## Summary of Dana Bartus' Proposal

**Save Terrebonne! Coalition  
Position Statement  
November 28, 2018**

**Attachment A**  
**Save Terrebonne!**  
Lower Bridge Way Improvements

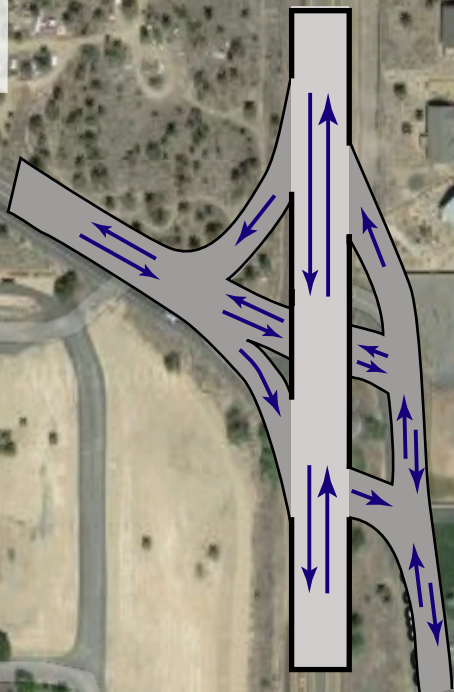
1. Improve Highway 97 within its existing alignment, until funding for a bypass becomes available.
2. Do not convert 11th Street into a highway couplet.
3. Build an overpass at the Lower Bridge Way that connects Lower Bridge Way and 11th Street, and allows vehicles, bicycles, and pedestrians to travel under the highway to Terrebonne, and safely access Highway 97 in both directions from appropriately designed on and off ramps, as shown on Attachment A.
4. Do not convert the Lower Bridge Way intersection into a roundabout.
5. Make other safety and livability improvements along Highway 97 and 11th Street, including:
